PIC18F24K20/25K20/44K20/45K20

PIC18F24K20/25K20/44K20/45K20 Silicon Errata and Data Sheet Clarification

The PIC18F24K20/25K20/44K20/45K20 devices that you have received conform functionally to the current Device Data Sheet (DS41303G), except for the anomalies described in this document.

The following typographic corrections and clarifications are to be noted for the latest version of the device data sheet (DS41303G):

40-Lead Ultra Thin Plastic Quad Flat, No Lead Package (MV) – 5x5x0.5 mm Body [UQFN]

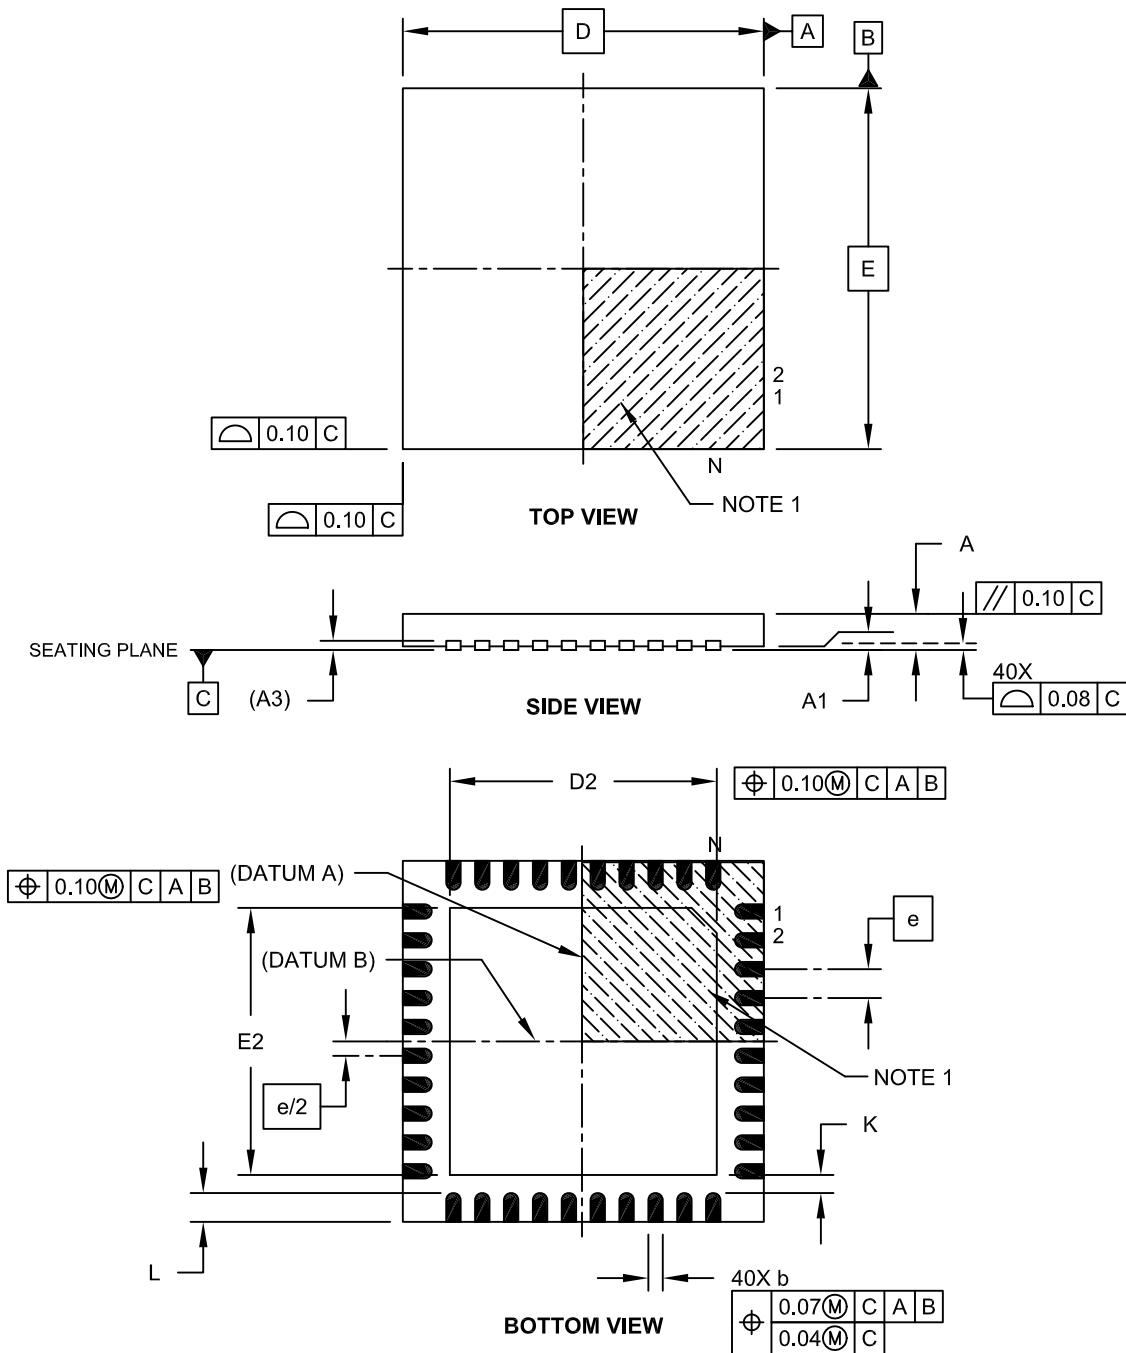
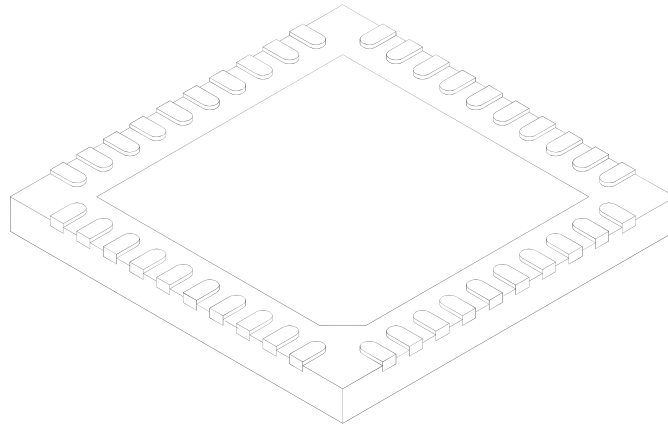
1. Module: Dimensions for UQFN Packaging Option
